Date of Document	11/04/16
Originator	Head Of Development
Originator's Ref (if any)	
Document Title	Response to Consultation by Scottish Government on Fallago Rig Windfarm

SUBJECT: Response to consultation by the Scottish Government on a (1) an application to vary the operational time limits for a windfarm at Fallago Rig under Section 36C of the Electricity Act (FR1) (2) an application for an extension within Scottish Borders Council area of the generating capacity of a windfarm at Fallago Rig through the construction of 12 turbines and associated works under Section 36 of the Electricity Acts (FR2)

APPENDIX 1: Response to ECDU

Fig. 1 Original Fallago Wind Farm Application Proposed Site Layout Plan April 2005

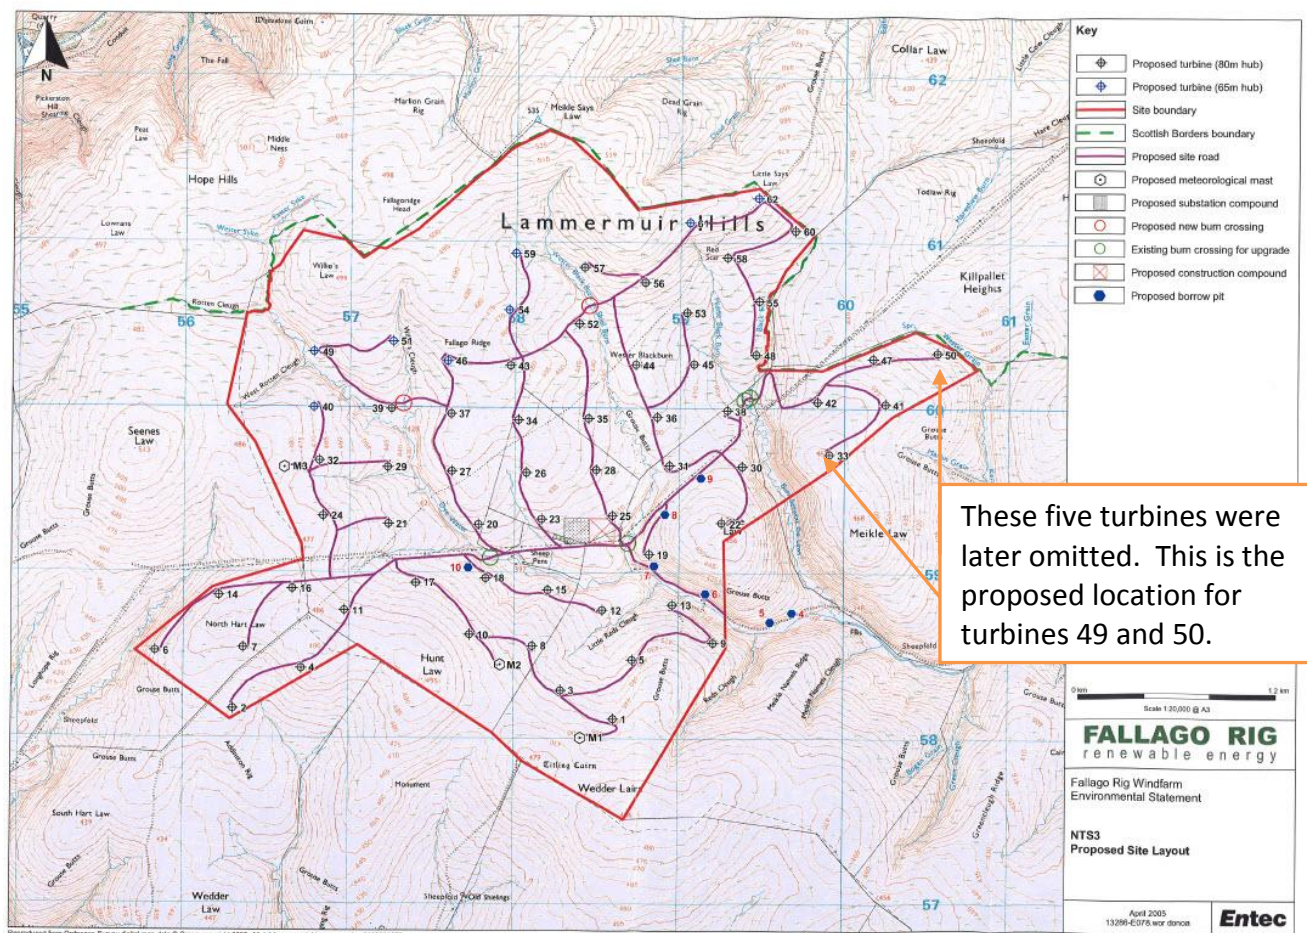
- 24. We note however that the applicant is now proposing two turbines, 49 and 50 in an area where turbines were proposed in the initial application for Fallago Rig and later omitted (Proposed Site Layout Plan April 2005 attached below). These two turbines extend onto hill slopes outwith the topographical bowl formation. As can be seen in the visual assessment above these turbines are noted in a number of viewpoints as being detrimental to the views and spreading the extent of the existing wind farm over the important Lammermuir skyline feature.

- 25. Due to the detrimental landscape and visual impact of turbines 49 and 50 these should be omitted from the scheme.

26. With regard to the ten turbines proposed to the south of the site there are a couple that we would prefer to see resited or removed. These are discussed in detail within each viewpoint. The most notable are:
 - 26.1. Turbine 60 has been indentified in a number of viewpoints from the north, 14, 17 and 18 with its hub sitting above the skyline and to the west of the existing wind farm containment. A reduction in height to bring the hub of this turbine below the skyline would answer this concern. If this is not possible then this turbine should also be omitted.
 - 26.2. Viewpoint 7 Priestlaw Hill turbines 52 and 53 have a particularly detrimental impact on the landscape setting of the valley and settlement of Killpallet. These turbines should be removed or resited to allow the retention of the landscape setting and character of this valley in this view.
